CITY OF BEAUFORT
Historic District Review
Board Full Board
Staff Report
Meeting of August 13, 2014

Case Number: HR14-36
Property Address: 1407 Duke Street
Applicant: Historic Beaufort Foundation
Type of Request: Alterations and Additions - Final
Zoning: GC – General Commercial (NWQ)

Re: 1407 Duke Street, The Frogmore Lodge

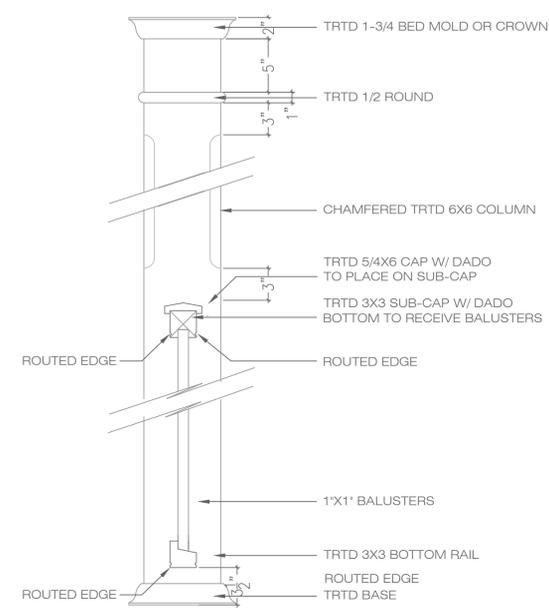
- **Reconstructing the front porch to a two-story, stacked porch, as is seen in the 1968 photograph;**
- **Removal of the dilapidated rear addition, and securing the rear opening with plywood.**

10. Add new porches at first and second floors as drawn using turned balusters in cedar to match 1968 photograph.

02 FRONT PORCH DETAILS
A4.1 SCALE 1/2"=1'-0"

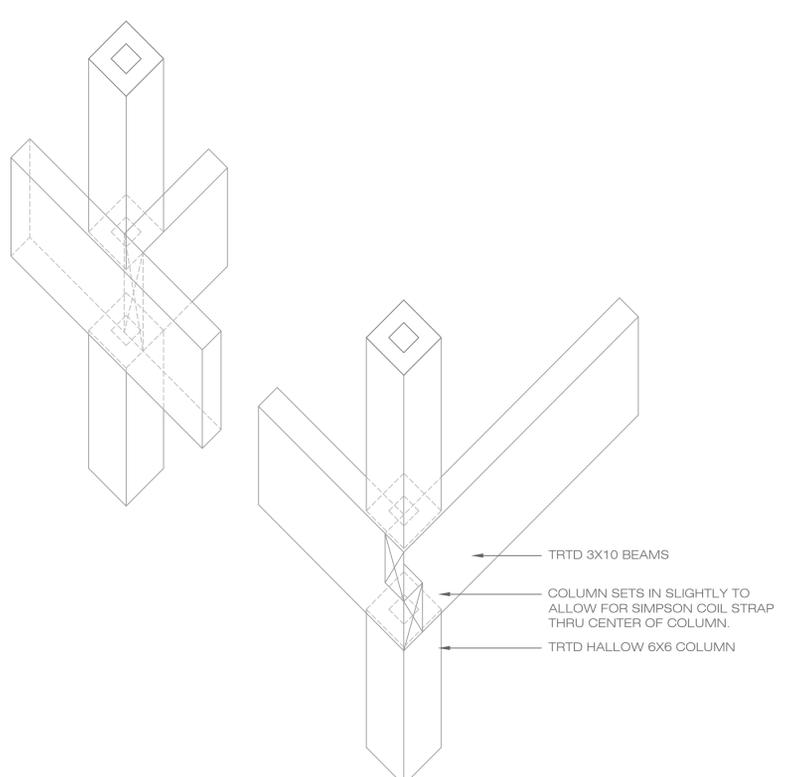
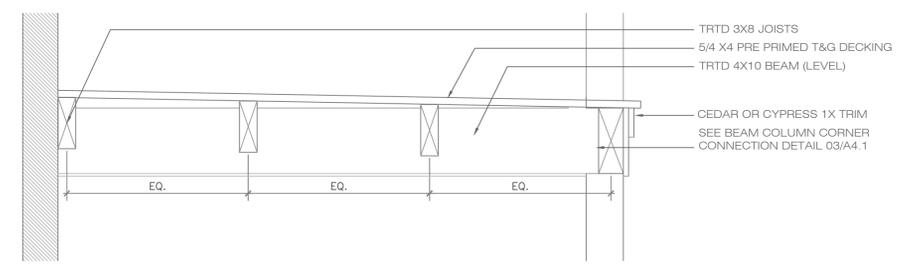
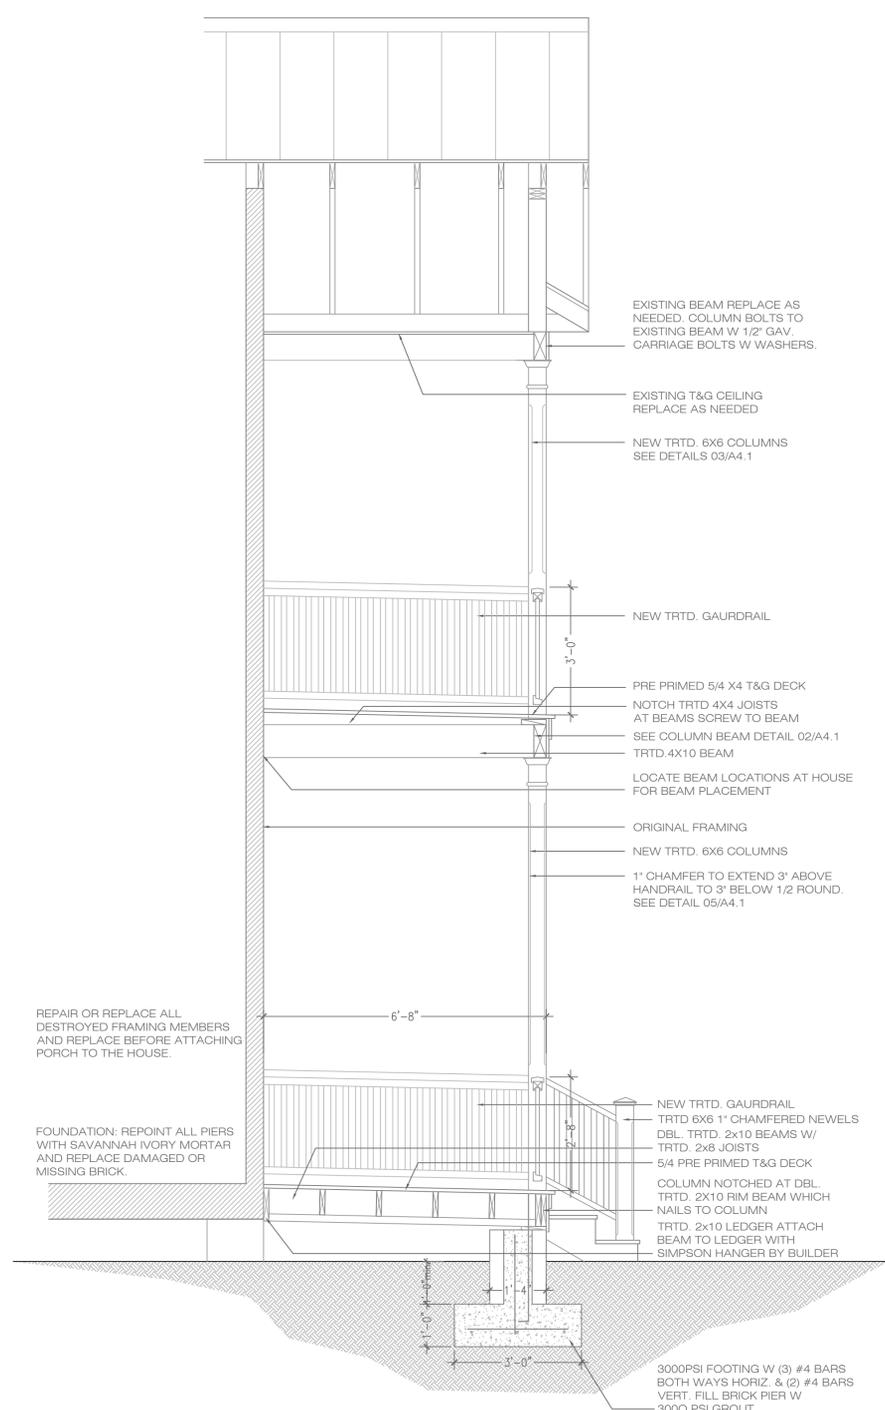
- In general these modifications will be a significant improvement to the structure, and will restore the front façade back to its original historic condition.
- The modifications meet the intent of the SOI Standards, as well as the Preservation Manual Supplement guidelines.
- Regarding the roof, there is currently a tarp that has been covering the roof for 18-24 months. The scope of work states that it will be refastened, treated, primed and painted. Is this to be included in this phase? Please provide a details and a timeframe for a permanent roof solution.
- Plywood securing building openings must be painted gray, or a color that blends in with the structure.

Staff Recommendation: Staff recommends final approval to this request, as submitted, with the condition that the roof be addressed in this phase as well.
